Appendix A: Draft Development Plans (Winton Partners)

NORTHLAKE DEVELOPMENT STAGES 1-7

NORTHLAKE DEVELOPMENT STAGES 1-14

Re: Proposed Development – North Lake, Wanaka

**Lower & Upper Pressure Zones
Overview of Stages 1 - 22
Proposed Water Supply Layout**

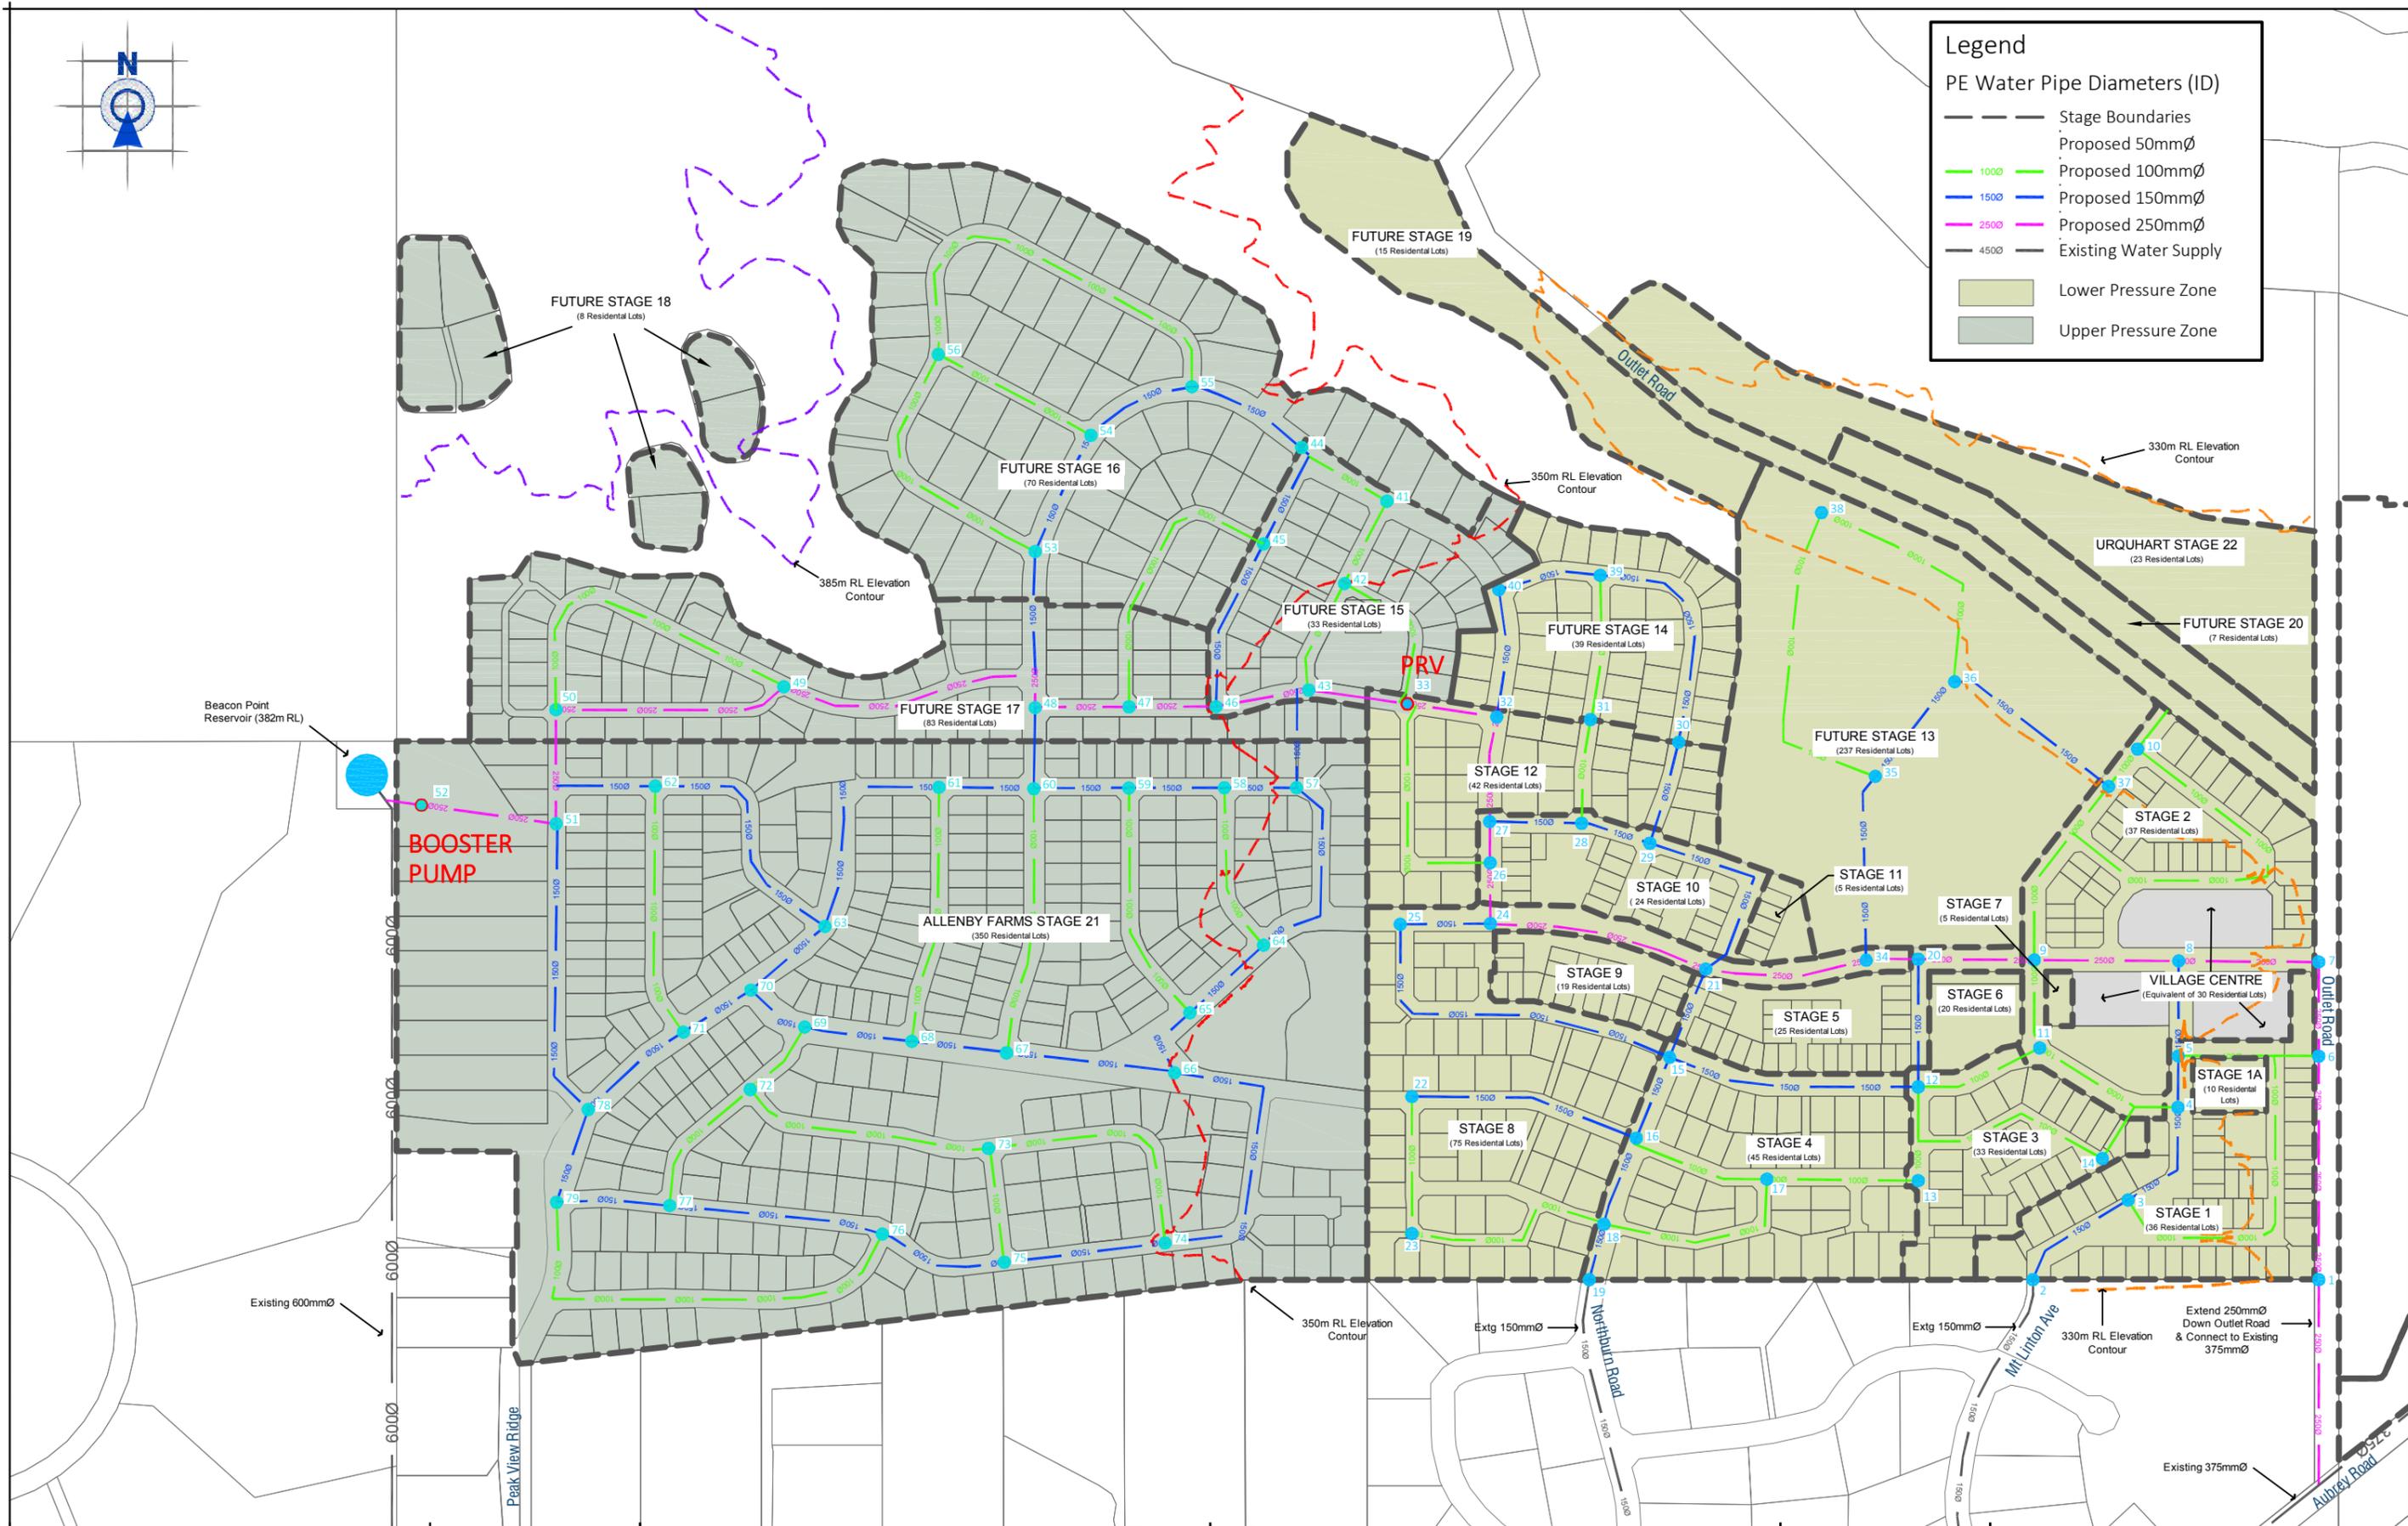
The demand has been assessed based on the Northlake Stages 1-14 Proposed Water Supply Layout drawing W4481-7 076 Sheet No. 600 Revision No. 3 and the Queenstown Lakes District Council Land Development and Subdivision Code of Practice (2015).

MODEL RESULTS WITHOUT 250MM CONNECTION

For current peak day demand, pressures within Stage 1 to 14 new sub-division are generally above 300kPa, with the exception of the Node 23 in Stage 8 which falls slightly below, at 295kPa. This would be within the margins of error of the hydraulic model.

Without the 250mm connection from Beacon Point the subdivision is supplied from the proposed new main on Outlook Road and connections through Northburn Road and Mount Linton Avenue. Under this scenario, the maximum head loss per unit length for the mains on these streets ranges from 3.5m/km on Outlook Road to 4.2 m/km on Mount Linton Avenue and to 5.4 m/km on Northburn Road.

Some of the proposed network diameters have changed since the previous assessment of Stages 1-7 undertaken in 2016. Of note is the watermain on Outlook Road which is now a 250mm diameter (previously 150mm) which will ultimately link through the development to Beacon Point Reservoir outlet main. This upgrade is essential to supplying stages 1-14 without the 250mm connection through to Beacon Point Reservoir.

It is also noted that a small area of Stage 14 is above the 350m contour. Consideration should be given to any proposed earthworks and to the proposed zone boundary between the Upper and Lower pressure zones to ensure these sites have sufficient pressures.

In terms of the wider water supply scheme proposed on drawing W4481-7 076 Sheet No. 600 Revision No. 3, it is recommended the pump station is dedicated to supplying only the Upper Pressure Zone. Options for the supply to the Upper Pressure Zone are currently being considered by QLDC and may include a high level reservoir rather than pumping direct online.

The proposed 250mm watermain should remain a gravity watermain through the Upper Pressure Zone to the Lower Pressure Zone. This limits the size of the pump station and ongoing energy costs of pumping excess water only for it to be pressure reduced into the lower zone. It may also be difficult to control the flow through the proposed pressure reducing valve as the Lower Pressure Zone is just part of the much larger Beacon Point Zone, this would then have implications for the design of the pump station, particularly if pumping is direct online.

The modelling results indicate that stages 1-14 can be supplied through the proposed reticulation layout on drawing W4481-7 076 Sheet No. 600 and meet the desired levels of service indicted by Queenstown Lakes District Council. Provided Queenstown Lakes District Councils are comfortable with the level of service provided to the properties on Glenaray Road, and the small area within Stage 14 above the 350m contour is addressed, the proposed water supply design can be accepted.

Figure 2- Wastewater schematic

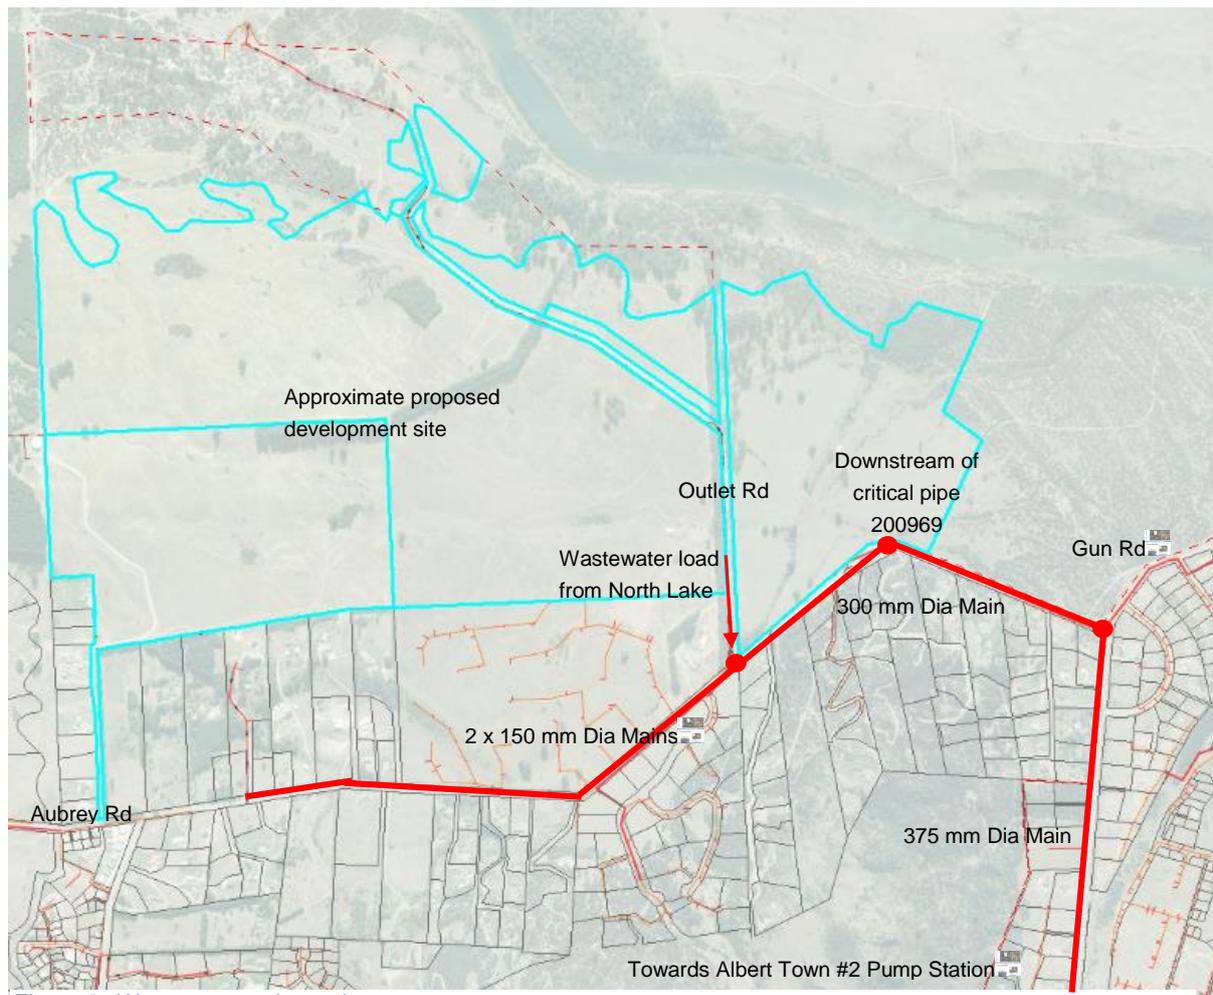
As per your email of 6 January 2016, we have assessed the impact of the proposed wastewater loads on the QLDC network. More specifically, the capacity of the existing 300 mm and 375 mm diameter trunk mains from Outlet Road along Aubrey Road with the additional discharge of wastewater from the proposed North Lake development and of maximum probable development within the catchment to Albert Town #2 Pump Station.

Two desktop assessments were completed using alternative load assumptions. The first using the load assumptions of the recently update subdivision code of practice (June 2015). The results of which indicated there was not sufficient capacity in the existing 300 mm or 375 mm diameter trunk mains. The second using the previously used load assumptions from the Land Development and Subdivision Infrastructure New Zealand Standard (2010) and lower unit occupancy rates which indicated there is sufficient capacity in the existing 300 mm diameter trunk main.

1. Alternative A, QLDC Land Development and Subdivision Code of Practise, June 2015, results confirm there is **not** sufficient capacity in the downstream 300mm or 375 mm trunk main (approx. 2.7 km of main, and maximum 6 m cover).
2. Alternative B, using the historic inputs, results indicate that the connection of the proposed development and of the maximum probable development in the existing catchment will not cause any additional capacity constraints.
